SEWAGE DISPOSAL SYSTEM

HOWARD COUNTY HEALTH DEPARTMENT

SUBDIVISION _____ LOT _____ ROAD 2873 Florence Road

REPAIR - PURPOSE - SEPTIC SYSTEM HAS FAILED.

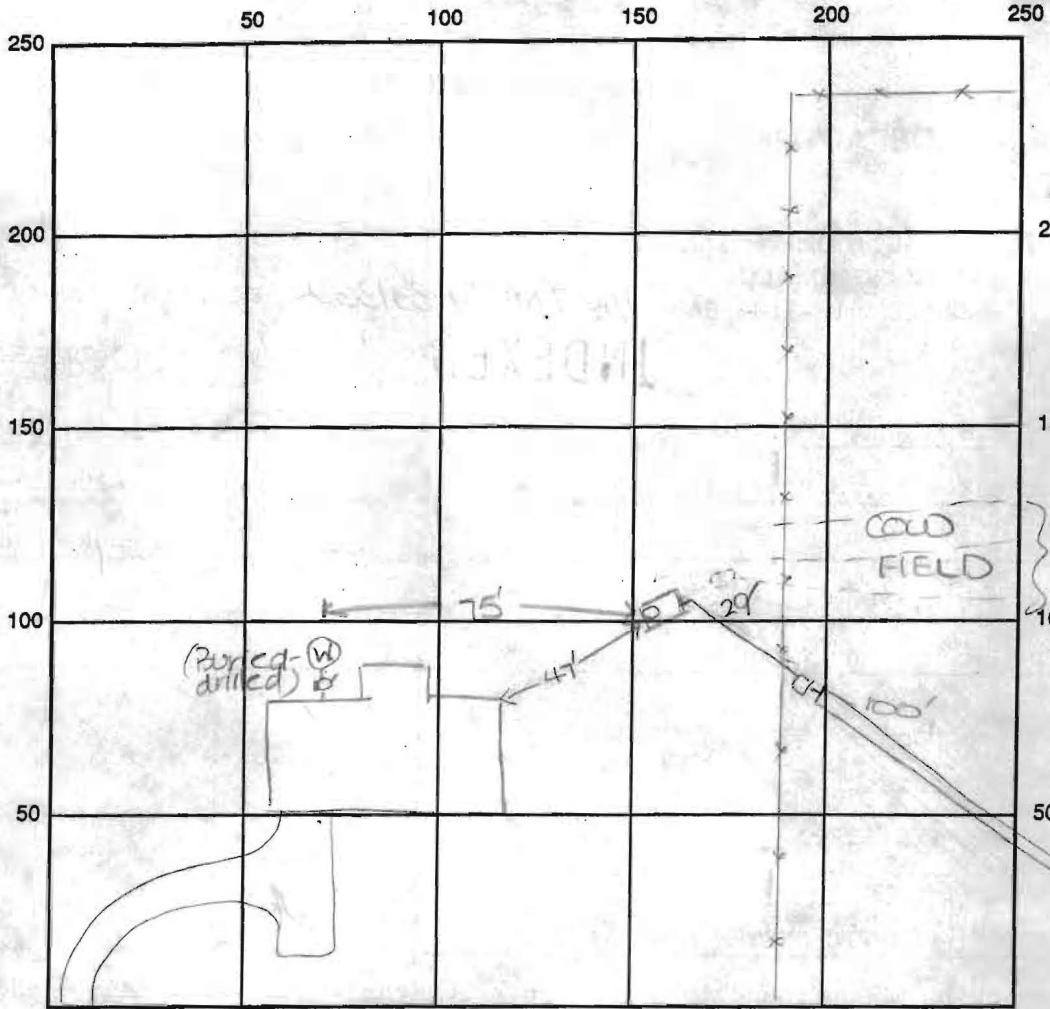
Existing drainfield to be disconnected

trench to be installed off existing septic tank on contour

Trench to be 3' wide, inlet 3.5', bottom 9.5', stone 6'

REMARKS: 4/9/08 OK to install and cover replacement trench as specified. Due to weather conditions, installer to provide documentation of work - no further inspection to be done. DKS
4/13/08 FINAL INSP - OK to cover all work. Failing septic system disconnected. DKS
